City of Sebastopol Planning Department

Meeting Date: December 19, 2018
Agenda Item No.: 8C
To: Tree Board
From: Dana Morrison, Assistant Planner
Subject: Tree Removal Permit
Recommendation: Approval for Removal of 3 Trees with Conditions
Applicant/Owner: David Fowler
File No.: 2018-96
Address: 755 Petaluma Avenue
CEQA Status: Categorical Exemption: Class 1
General Plan: Commercial Office
Zoning: General Commercial

Findings for Approval **Application No. 2018-96** **755 Petaluma Avenue**

PLANTING PLAN

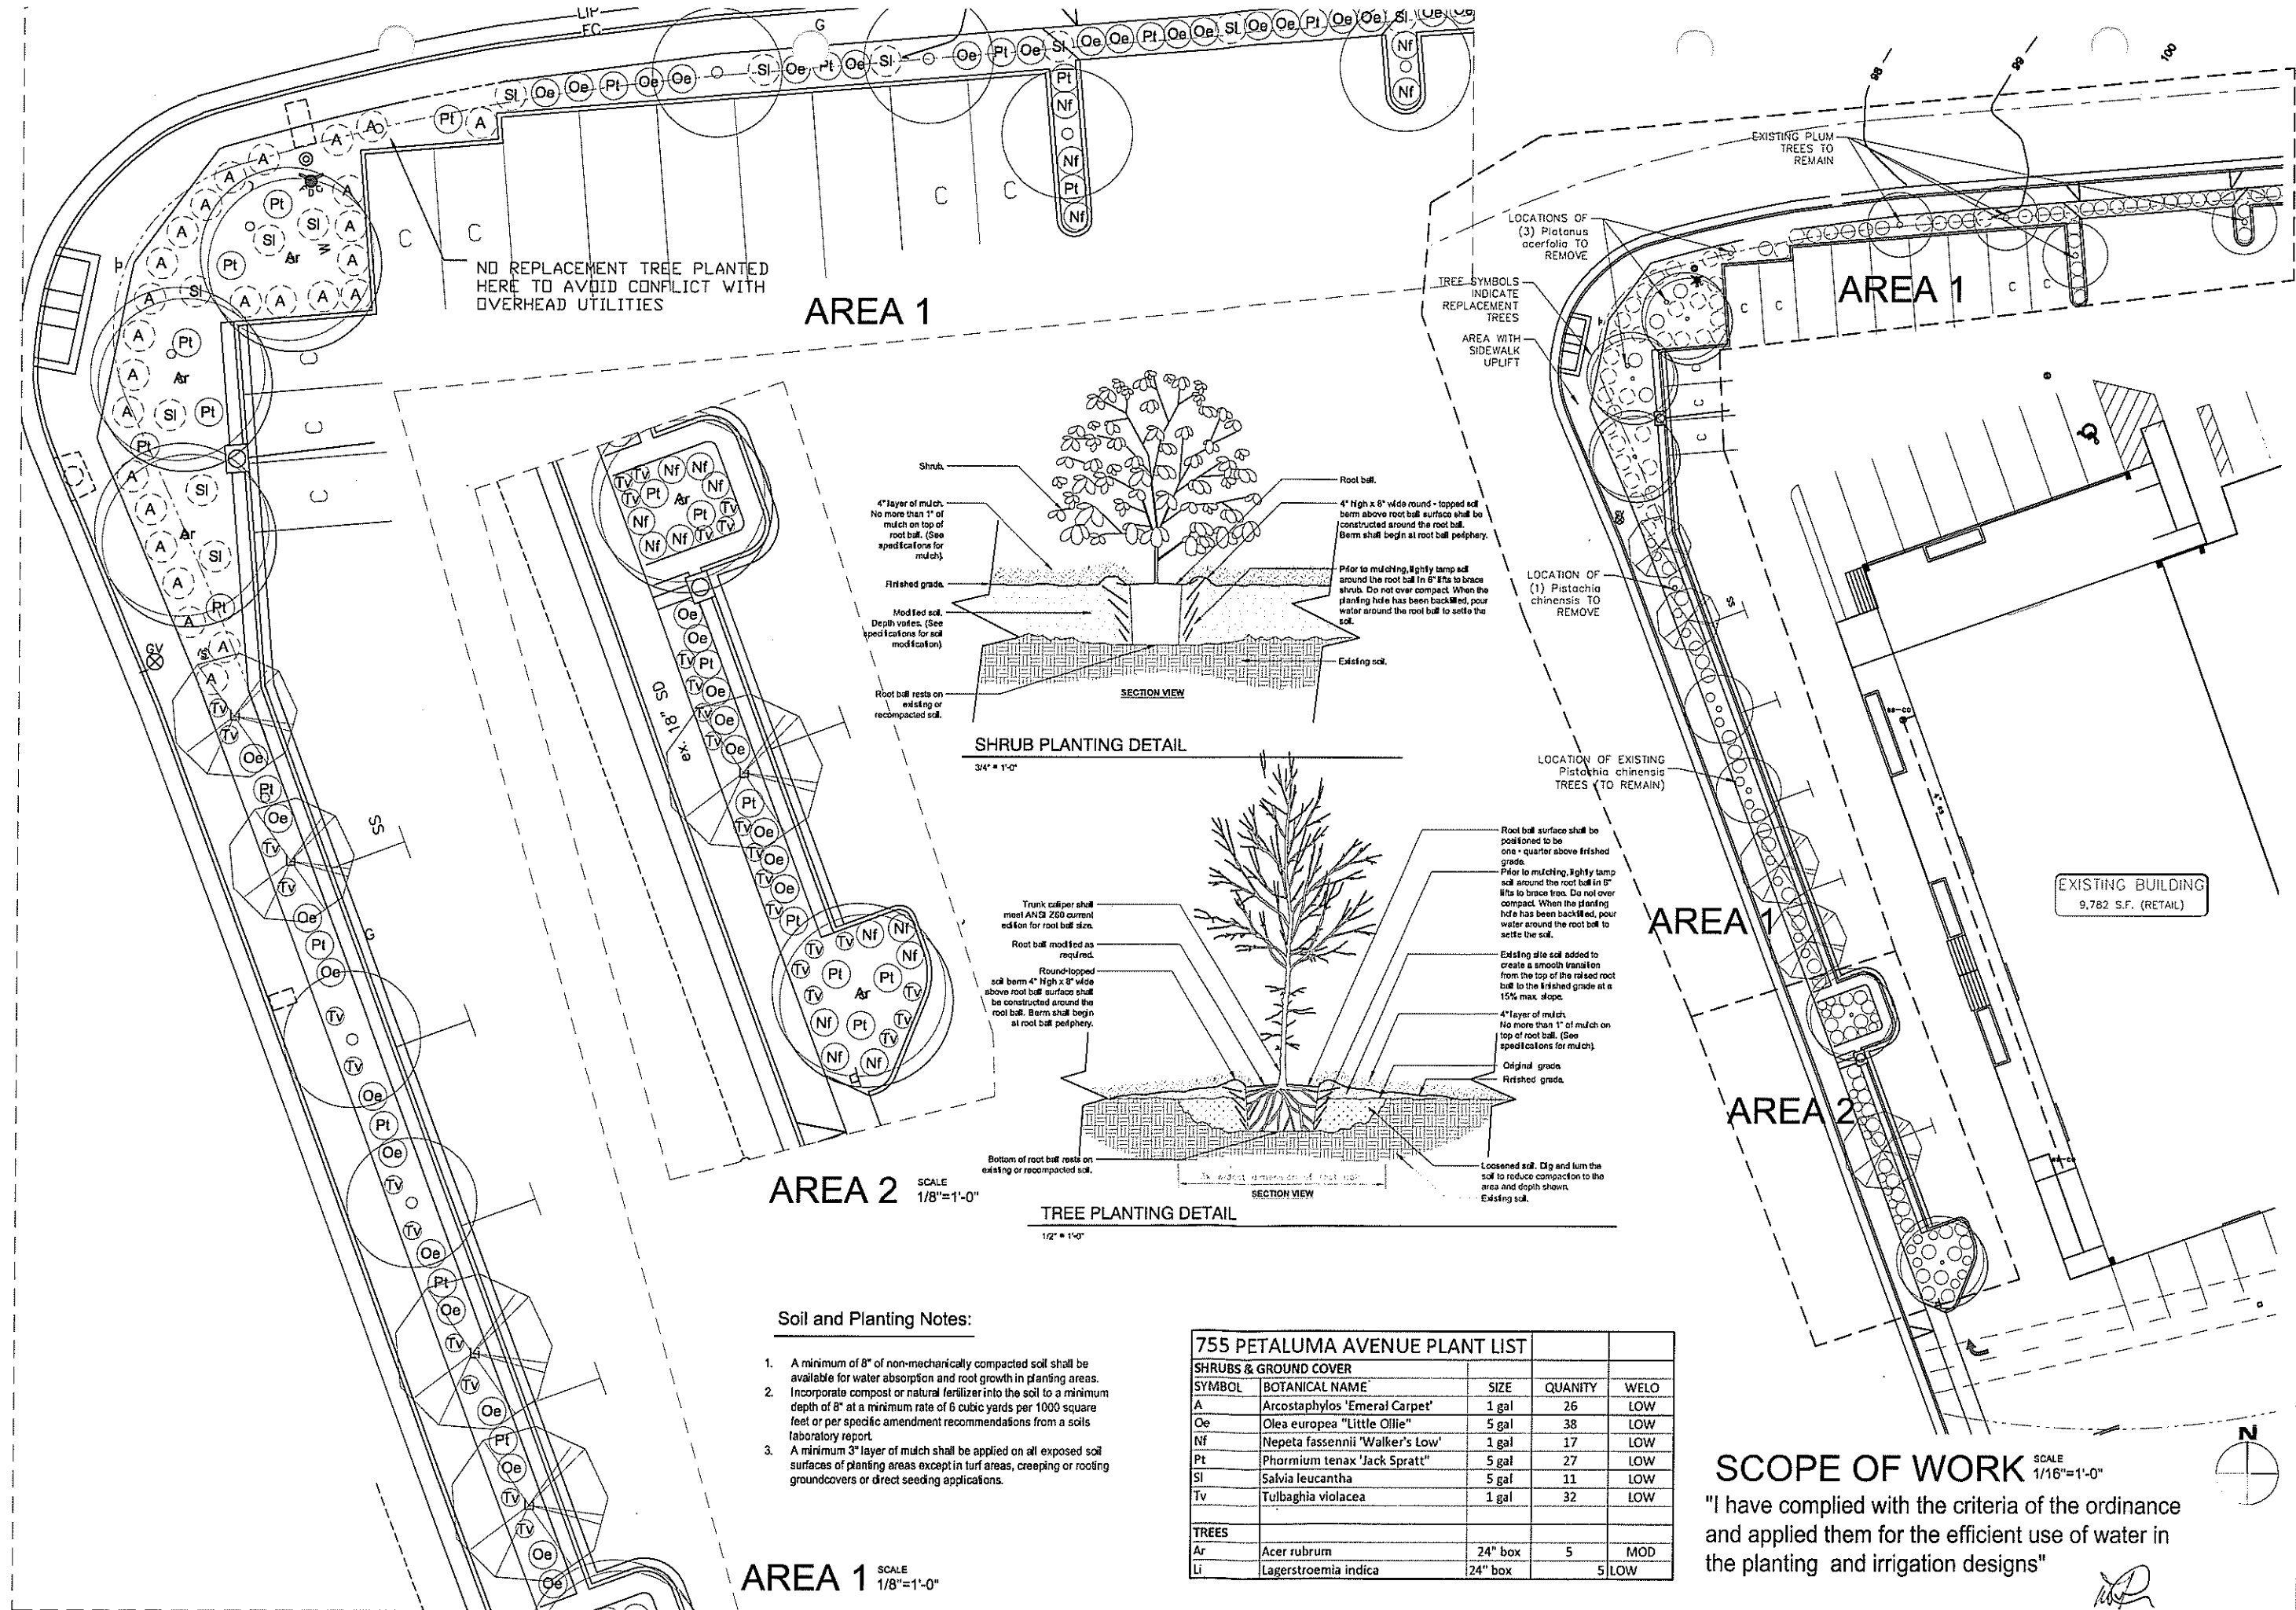
I have visited this site several times to assess the status of the street trees proposed for removal. The second application for tree removals submitted by the owner's landscape architect requests a slightly different group of tree removals than the August proposal. Three London plane/*Platanus acerifolia* are proposed for removal (as before) and a small (8" dbh), declining Chinese pistache/*Pistacia chinensis*. The pistache had previously been approved for removal.

Because the London planes are causing damage to the curbs and utility boxes and will continue to do so, after reconsidering this request, they may be removed and replaced. They are a large-growing species and are too crowded in this corner planter.

From the City's perspective, I do not agree with the proposed replacement selections/locations. It is important aesthetically to continue the maturing, beautiful Chinese pistache along the Petaluma Ave frontage which begins a few blocks south of this location. It creates an attractive continuous allee of the same species, with great fall color and good canopies. The removed pistache should be replaced with another boxed specimen. The southernmost London plane should also be replaced with a pistache on the Petaluma Ave. end of that corner. A crape myrtle or can be planted on the Palm Ave end of the corner and to replace the to-be-removed cryptomeria in front if desired. The red maples can be used somewhere else on (or off) the site – the east or south sides/ends.

2. The replacement of trees shall consist of one pistache tree (for replacement of the London plane closest to Petaluma Avenue) and two crape myrtles (for replacement of the other two trees proposed for removal).

3. If replacement trees are 24" box, or larger, than a 1:1 replacement shall be acceptable.
4. If replacement trees are smaller than a 24" box, then a 2:1 replacement shall be required.

5. The red maples may be planted elsewhere on the property, but have not been approved as replacement trees.
6. All replacement trees shall have irrigation.
